Work Order ID 139379

Item ID: D212-725-1-225

Item Name: Seal Retainer

Work Order: <u>139379</u> Part No. <u>D212-725-1-225</u> NCR No. <u>16-5527</u>	DISPOSITION Rework ☐ Scrap ☐ Use-as-is ☐ Suspected Unapproved ☐	AGAINST DEPARTMENT/PROCESS			
		Skid-tube ☐	Cross tube ☐	Water Jet ☐	Engineering ☐
		Machining ☐	Small Fab ☐	Prod. Eng. Coord. ☐	Quality ☐
		Thermoforming ☐	Finishing ☐	Rec/Store/Packaging ☐	Other ☐
		Large Fab ☐	Composite ☐	Supplier ☐	
Date: 15.12.01	Step #:	QTY Effective:			MRB (QSI042) Approval <i>A.P.</i> 15.12.01
Description Work Order Deviation		Disposition

D212-725-1-225 SEAL RETAINER

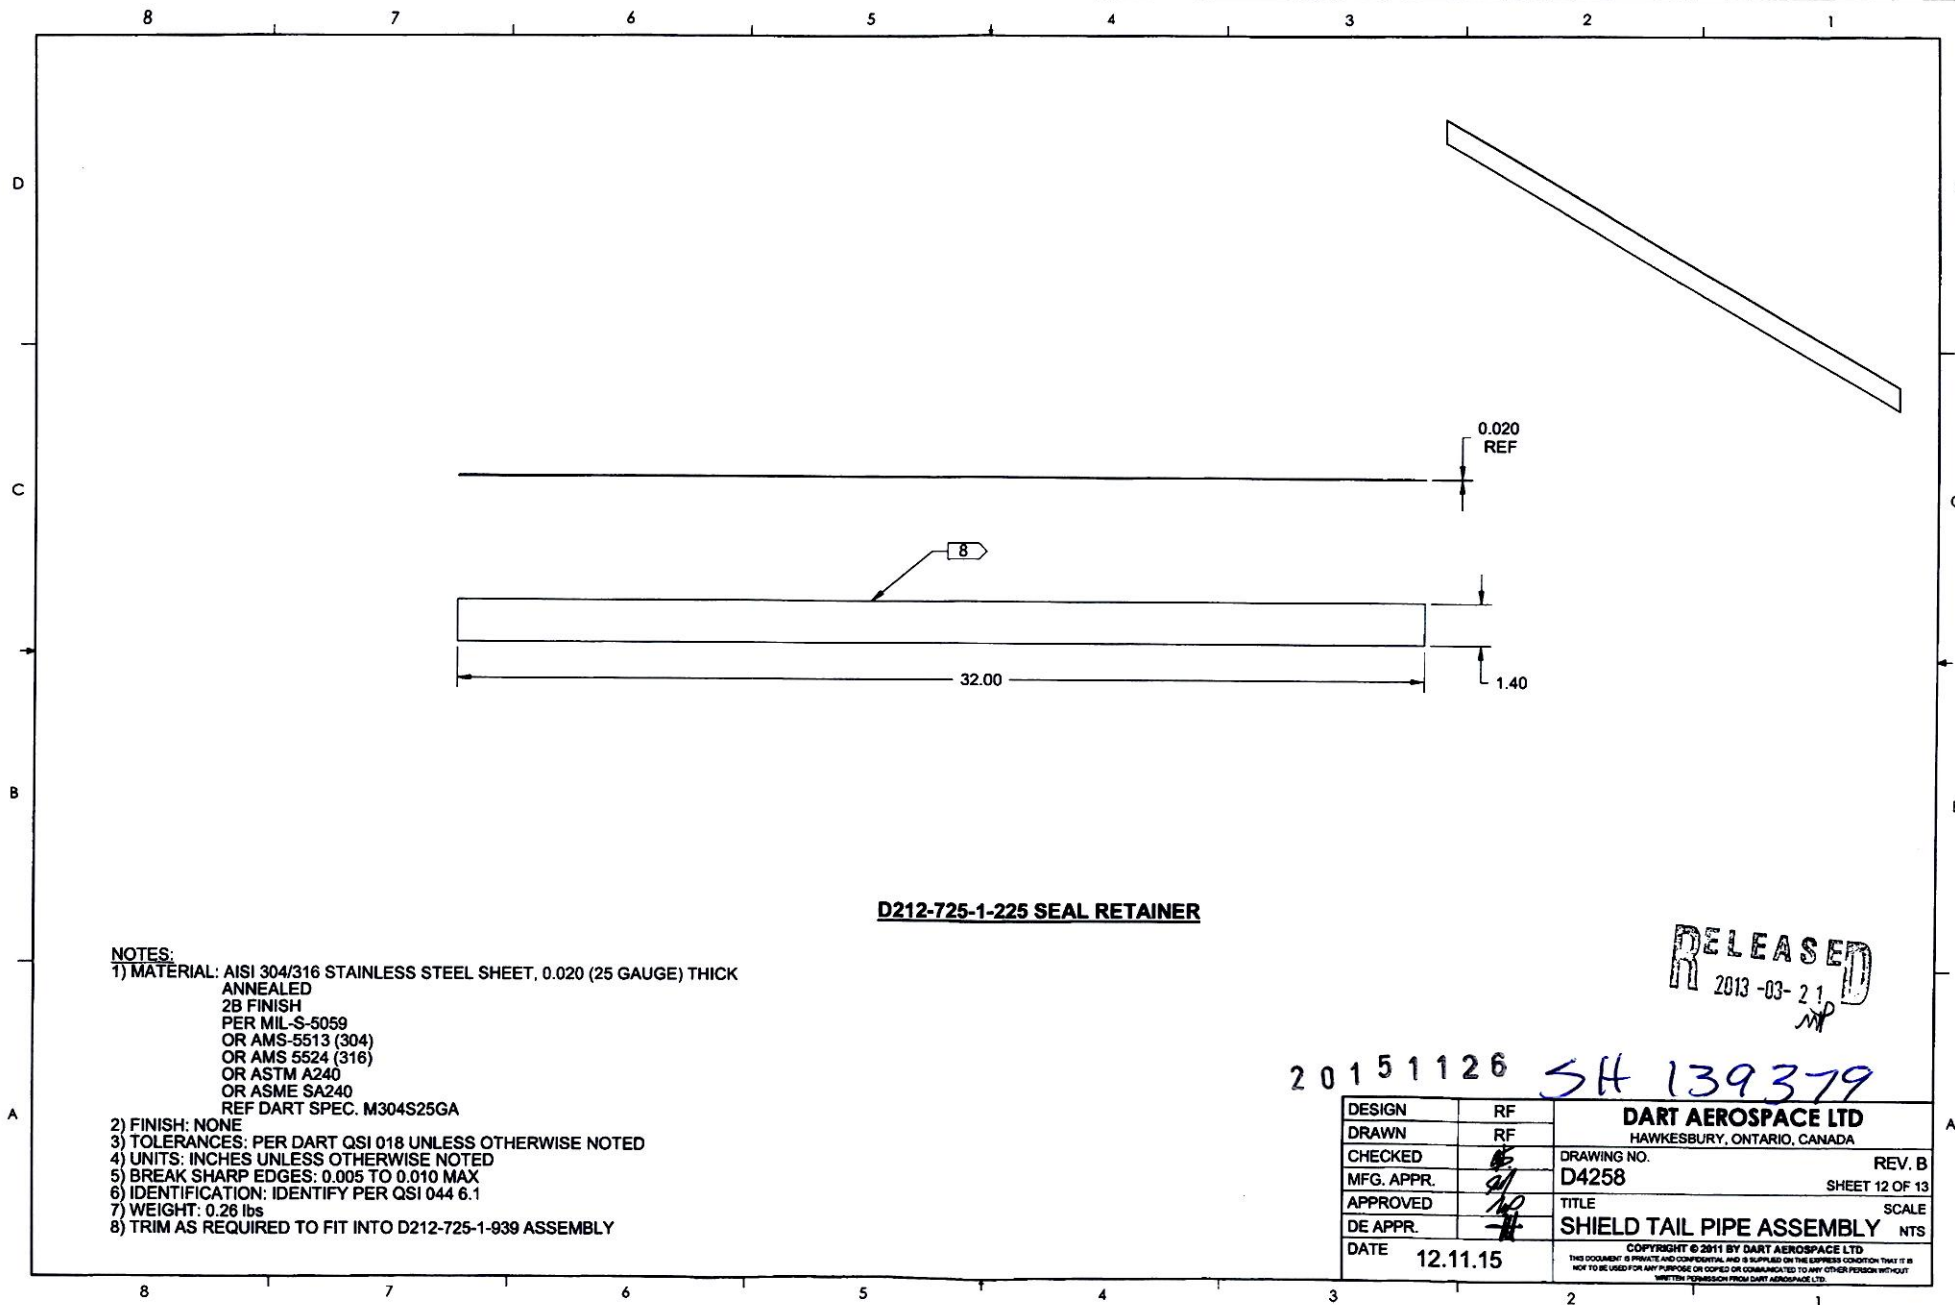
0.025 THK (24 GAUGE) USED		ACCEPTABLE, OPEN PAR TO CHANGE ON D212 → D4258 DRAWING, MTL SHOULD READ "0.025 THK (24 GAUGE)" <i>PAR 16.182</i>			Completed By <i>A.P.</i> 15.12.01 Lead hand / Supervisor Approval Verification <i>DAS</i> <i>38</i> <i>9-89</i> <i>DEC 09 2015</i> QC / QA Coordinator Approval <i>9</i> <i>9-89</i> <i>15-12-15</i>
Root Cause		FAULT CATEGORY			
Environment ☐ Design ☐ Doc/Data ☐ Equip/Tooling ☐ Handling/Pre ☐ Material ☐ Internal Transport ☐ Tribal Knowledge ☐ LOA ☐ Substation ☐ Past Expiry Date ☐ Misidentified ☐	No Re-verification ☐ Operator ☐ Offset/Setup ☐ Supplier ☐ Training ☐ Use for Testing ☐ Poor Information ☐ Rushing ☐ Product Improvement ☐ Process Improvement ☐ Manufacturing Process ☐ Past Due ☐	Pressure/Forced ☐ Bending ☐ Centre Not Concentric ☐ Cracks ☐ Crimp/Kink/Ripple/Wave ☐ Cuffs ☐ Crushing ☐ Heat Treat ☐ Wave/Twist in Tube ☐ Marks/Chatter ☐	Temperature/Cure ☐ Set-up ☐ BOM/Route ☐ Broken/Damage/Defect ☐ Inspection Incomplete/Unqualified ☐ Contamination ☐ Countersink ☐ Cut Too Short ☐ Instructions Incomplete/Unclear ☐ Drill Holes ☐	Power Loss/Surge ☐ Folio/Program ☐ Grain ☐ Weld ☐ Wrong Stock Pulled ☐ Out of Sequence ☐ Off-set ☐ Misabeled ☐ Fit/Function ☐ Misaligned/off center ☐	Positioned Wrong ☐ Outside Dimensions ☐ Over/Under tolerance ☐ Part Incorrect ☐ Part Lost/Missing ☐ Part Moved ☐ Drawing ☐ Finish ☐ Misread ☐ Turning Sequence ☐
